**CITY COUNCIL WORK SESSION
WITH THE WOODROW WILSON BRIDGE NEIGHBORHOOD TASK FORCE
ON NOISE MITIGATION**

**TUESDAY, FEBRUARY 26, 2002
6:00 P.M.
COUNCIL WORKROOM**

Re: Woodrow Wilson Bridge Project
Noise Abatement Coordination Issues

Proposed Noise Barrier on W.W. Bridge

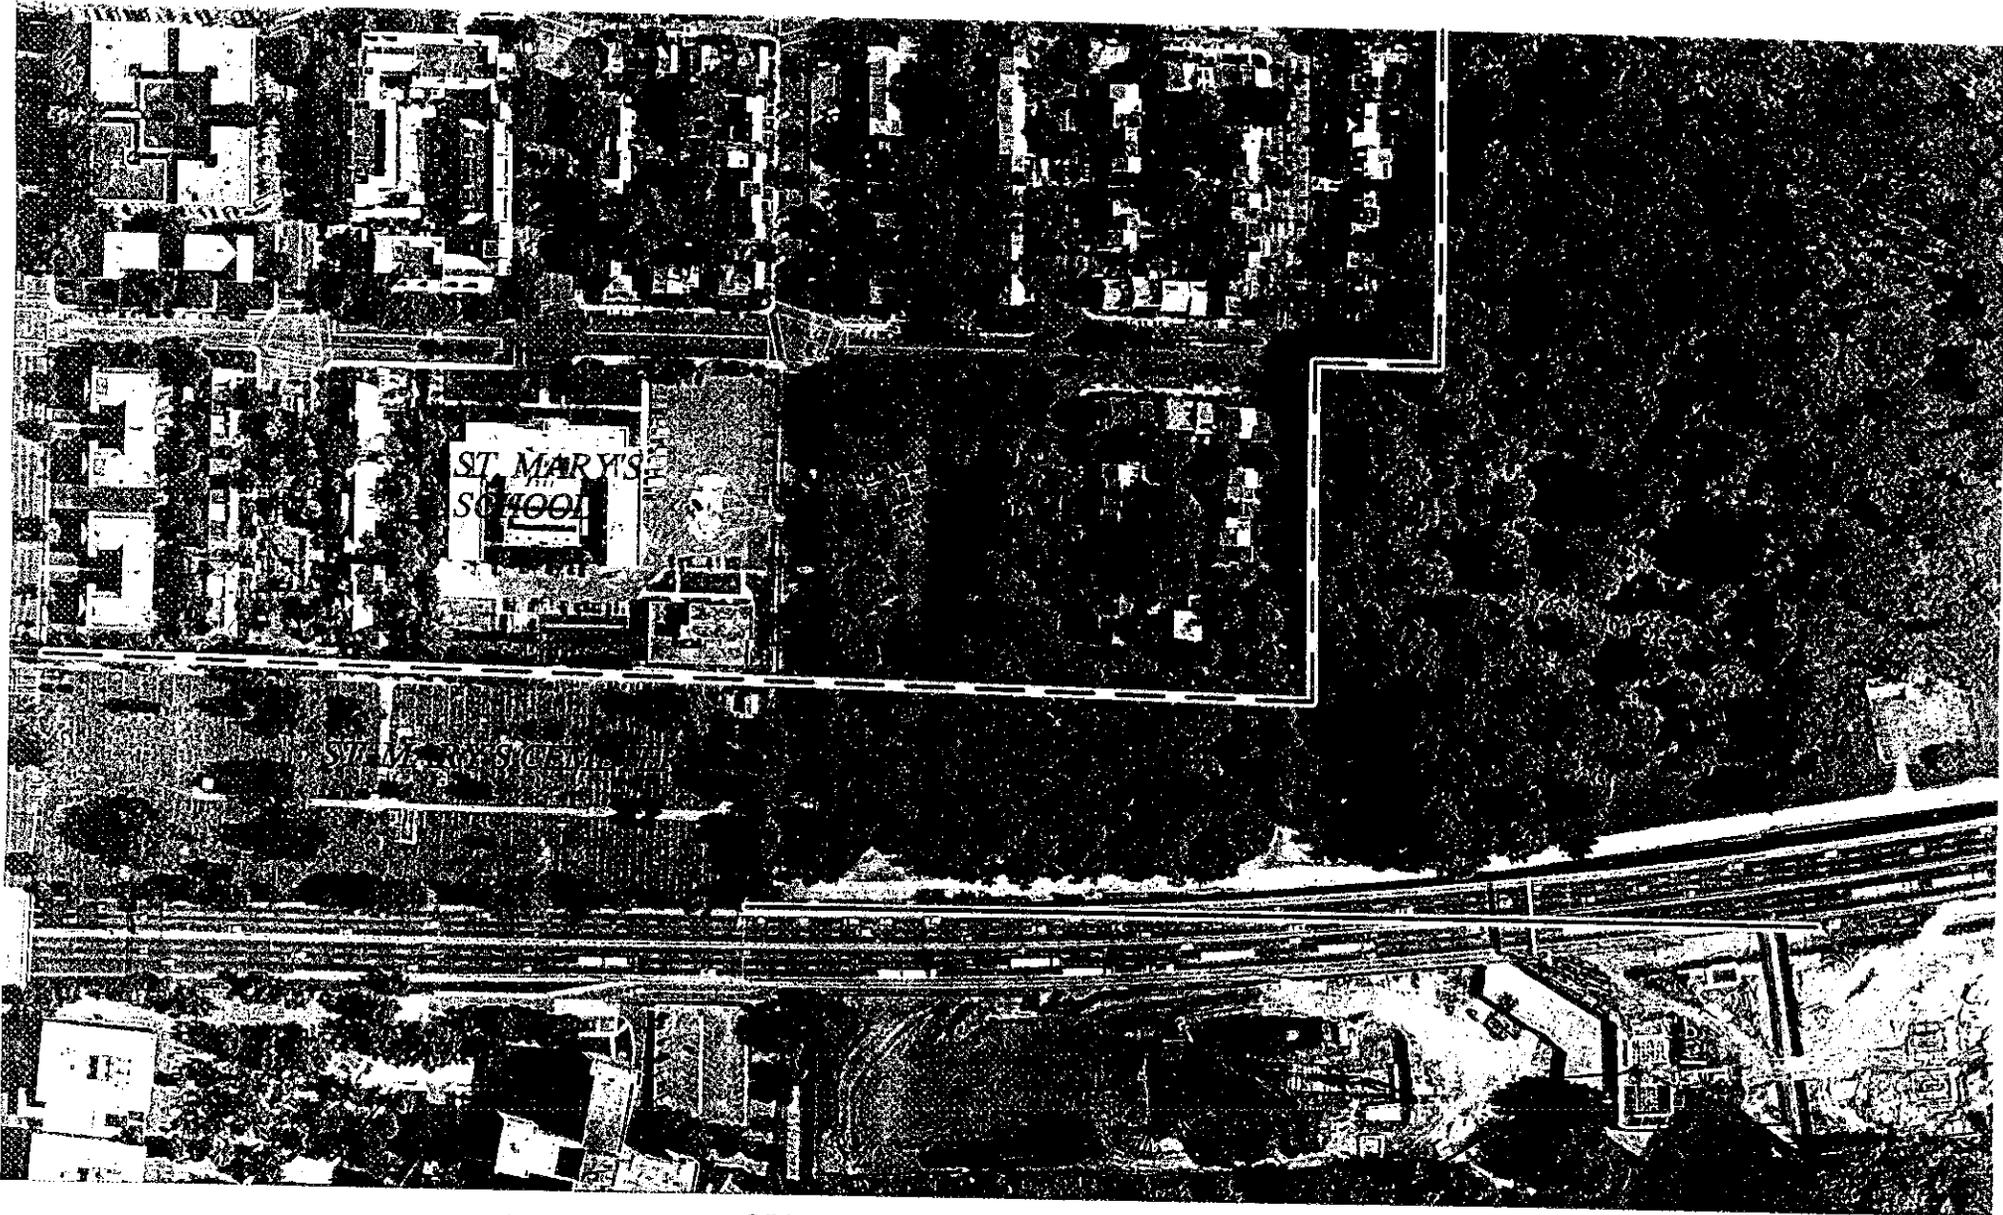
For the reasons outlined during our meeting, the City respectfully requests your reconsideration of the placement of a noise barrier along a portion of the north side of the proposed bridge as it runs through Jones Point Park (please see enclosed map). In addition, the City requests your consideration of a VDOT-funded community enhancement program for in-home improvements (e.g., multi-pane windows and/or sound insulation) for the affected residences in the Yates Garden community (outlined on the enclosed map). Virginia and Federal Highway Administration noise abatement criteria would guide the determination of eligibility for this program, which could be administered by the City.
